International
Aero Engines

V2500 Propulsion System — Nacelle

NACELLE — POWERPLANT — TRANSLATING SLEEVE, THRUST REVERSER —
MODIFICATION OF — SEAL, THRUST REVERSER — REPLACEMENT OF

V2500-NAC-78-0146

Lower Translating Sleeve Modification (with no or minimum disbond)
Figure 6 (Sheet 1)

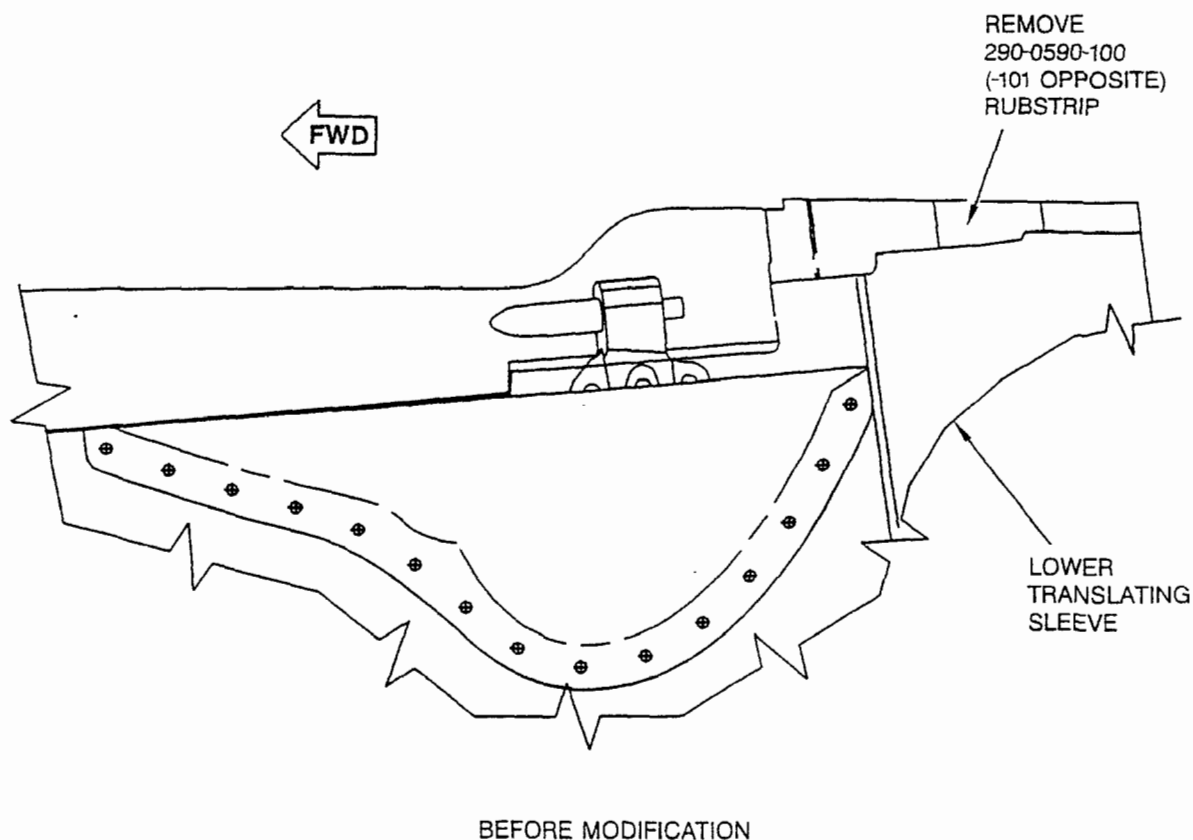
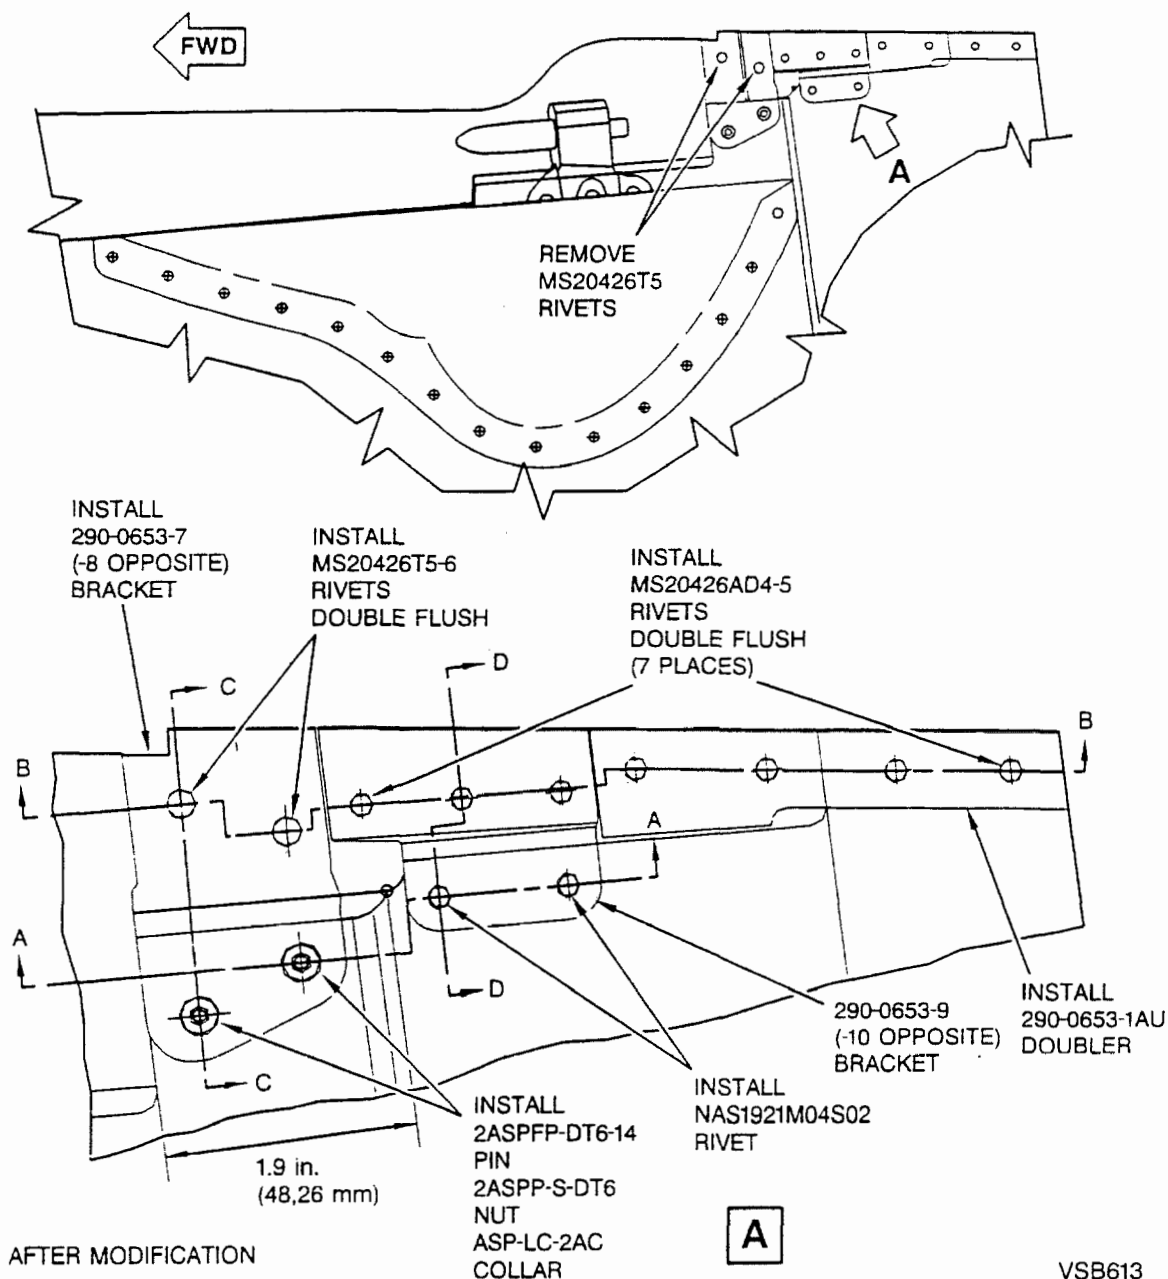
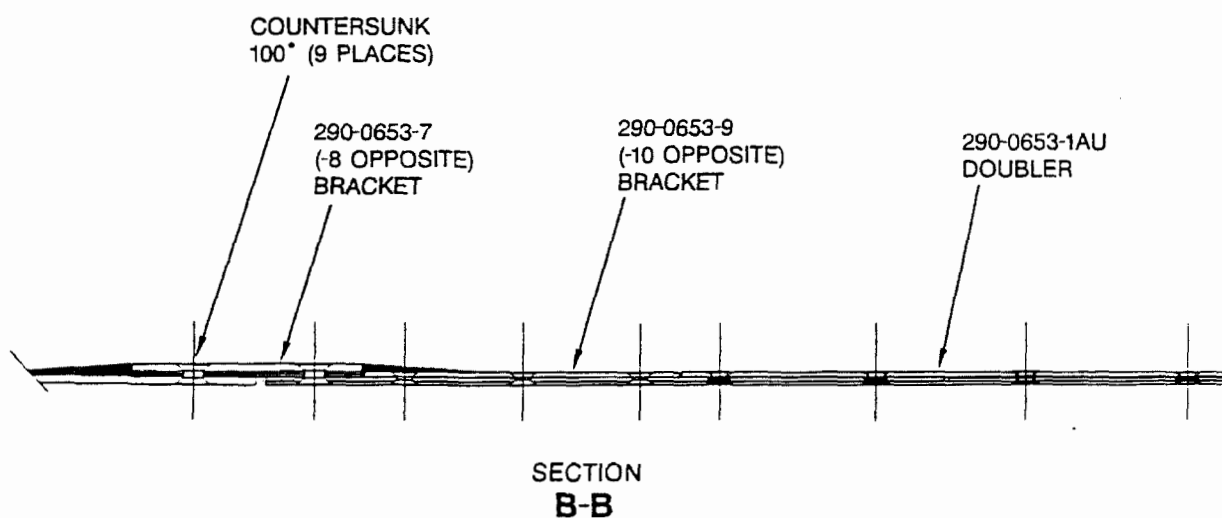
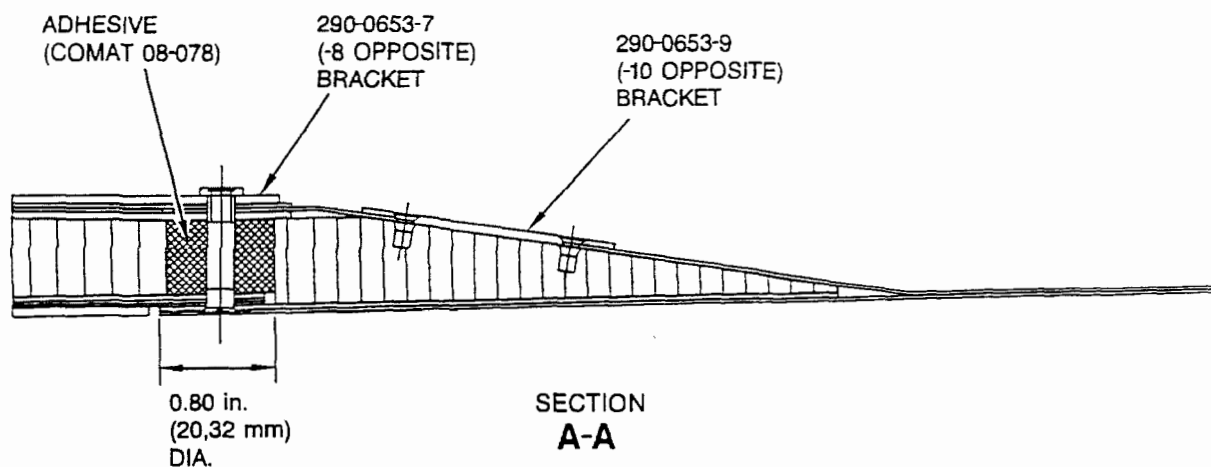
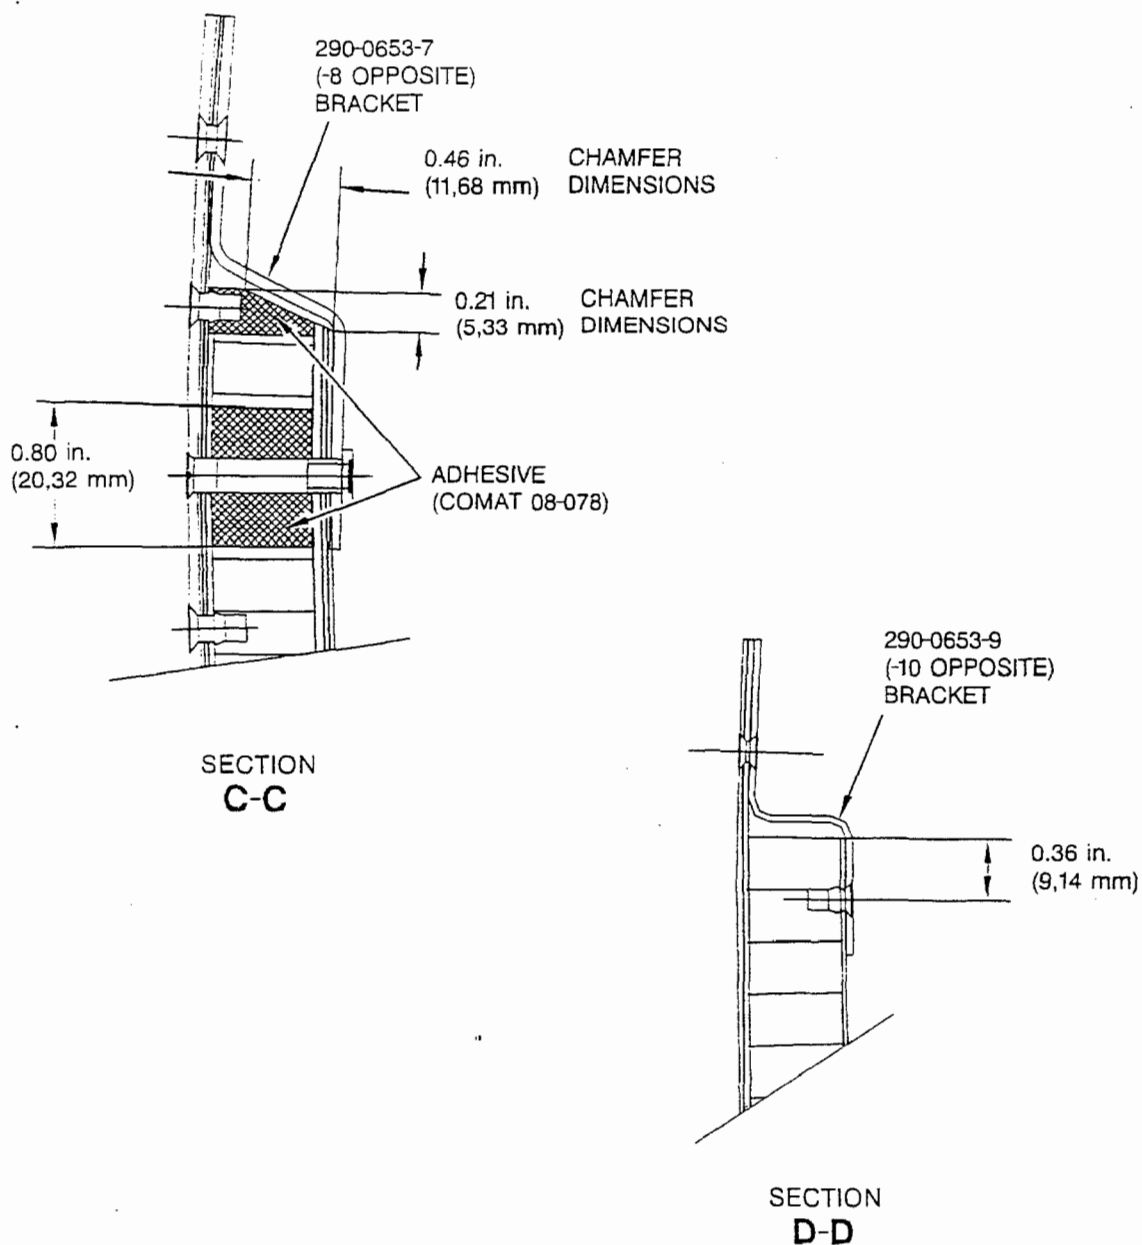
- (1) Remove the bonded rub strip 290-0590-100 (290-0590-101). Refer to Figure 6 (sheet 1).
- (2) From the inner side of the translating sleeve, remove one rivet MS20426T5. Refer to Figure 6 (sheet 2).
- (3) Make a chamfer on the acoustic panel. Refer to Figure 6.

- (4) Flush the bond repair area with solvent (CoMat 01-438) and force air dry for 30 minutes minimum. Repeat as necessary.
- (5) Prepare two fastener holes for the 290-0653-7 (200-0653-8) bracket. Refer to Figure 6.
 - (a) Put the 290-0653-7 (290-0653-8) bracket into position and make marks for the fastener holes.
 - (b) At the positions marked in step (a), drill 0.125 inch (3.18 mm) holes through the inner skin and the core. Do not drill through the outer skin.
 - (c) Remove the core to a diameter of 0.75 inch (19,05 mm) through the holes drilled in step (a).
 - (d) Clean the area around the holes with a clean lint free cloth (CoMat 02-099) made moist with solvent (CoMat 01-438). Rub the surfaces dry before the solvent becomes dry.

(1) Remove the bonded rub strip 290-0590-100 (290-0590-101). Refer to Figure 6 (sheet 1).

R (2) From the inner side of the translating sleeve, remove one
R rivet MS20426T5. Refer to Figure 6 (sheet 2).

(3) Make a chamfer on the acoustic panel. Refer to Figure 6.

(5) Prepare two fastener holes for the 290-0653-7 (200-0653-8) bracket. Refer to Figure 6.

- (11) Install the brackets and doublers with the fasteners. Wet install the fasteners with adhesive (CoMat 08-078). Refer to Figure 6.
- (12) Cure the adhesive under mechanical pressure for 2 hours at room temperature then for 2 hours at 200 ± 10 degrees F.
- (13) Trim brackets and doublers to agree with the shape of the acoustic panels.
- (14) Clean the bare metal surfaces with a lint free cloth (CoMat 02-099) made moist with solvent (CoMat 01-438). Wipe the surfaces dry before the solvent becomes dry.

(11) Install the brackets and doublers with the fasteners. Wet install the fasteners with adhesive (CoMat 08-078). Refer to Figure 6.

Replace the Thrust Reverser Seal
Figure 7

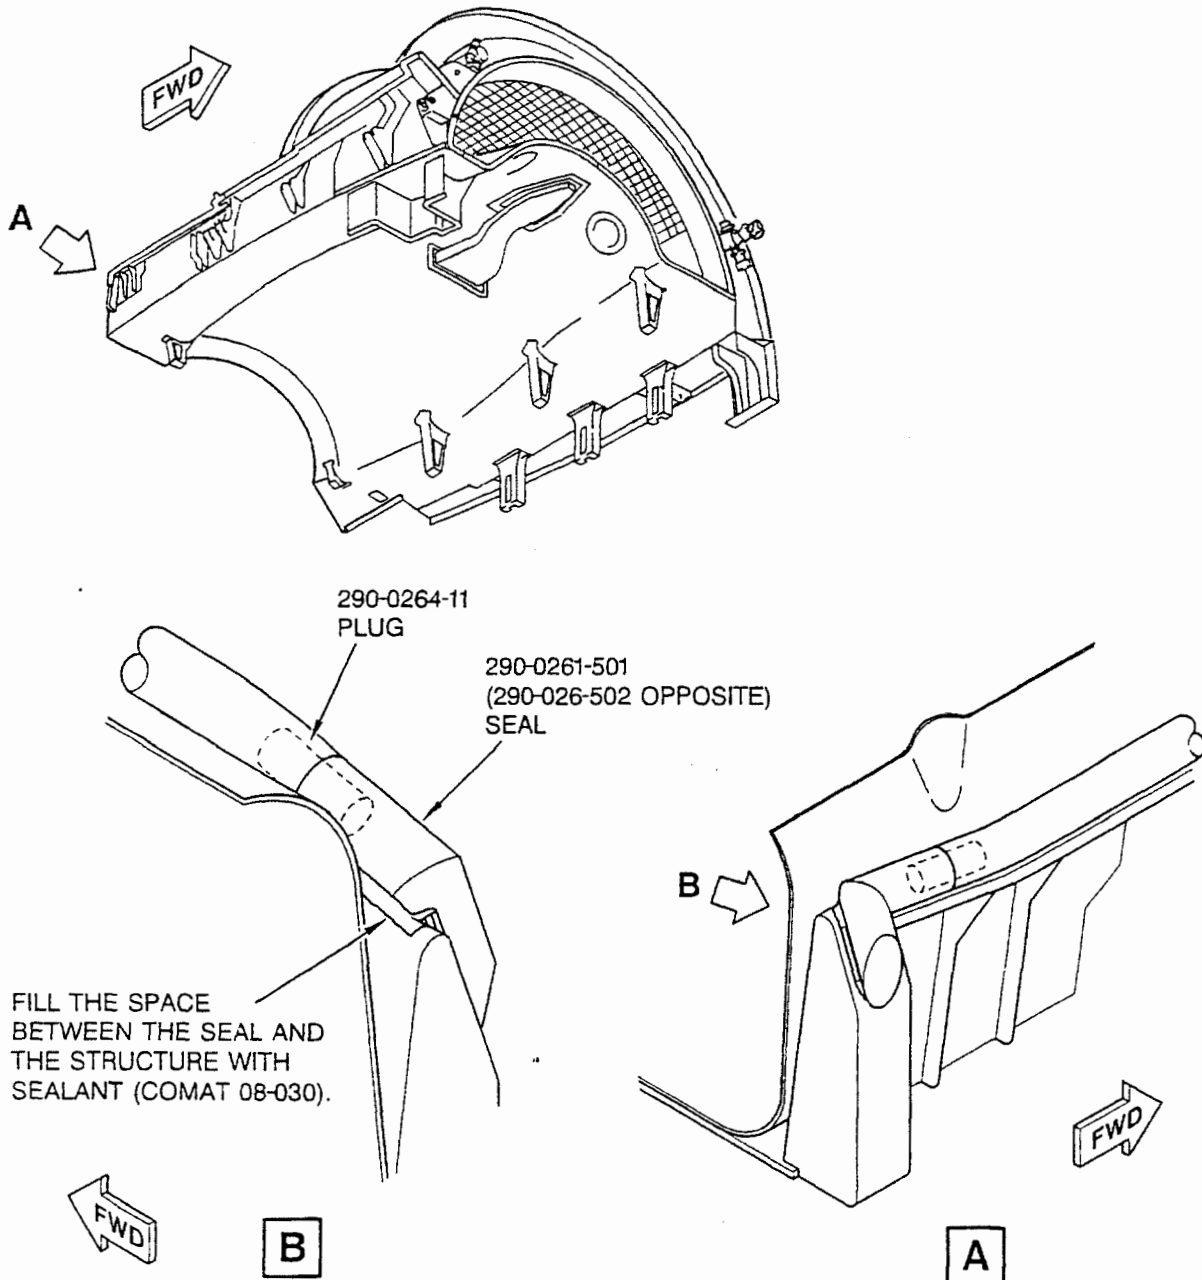
I. Replace the 290-0261-501 (290-0261-502) seal.

- (1) Remove the 290-0261-501 (290-0261-502) seal from the seal carrier on the thrust reverser fixed structure. The seal is attached to the adjacent seal with a plug seal. The plug seal is bonded to the seals with silicone rubber compound. Do not damage the adjacent seal during removal. Remove the splice plug. Refer to Figure 7.
- (2) Remove as much of the red sealant and clear silicone rubber compound from the seal carrier as possible.
- (3) Install the replacement 290-0261-501 (290-0261-502) seal on the seal carrier.

- (f) Install the seal in the seal carrier and on the 290-0264-11 seal plug. Make sure the vent holes face upward.
- (g) Remove unwanted silicone rubber compound with a lint free cloth (CoMat 02-099) made moist with solvent (CoMat 01-438).

- (h) Fill the gap between the seal and the structure with sealant (CoMat 08-030). Refer to Figure 7.
- (i) Cure the silicone rubber compound. Refer to the manufacturer's instructions.
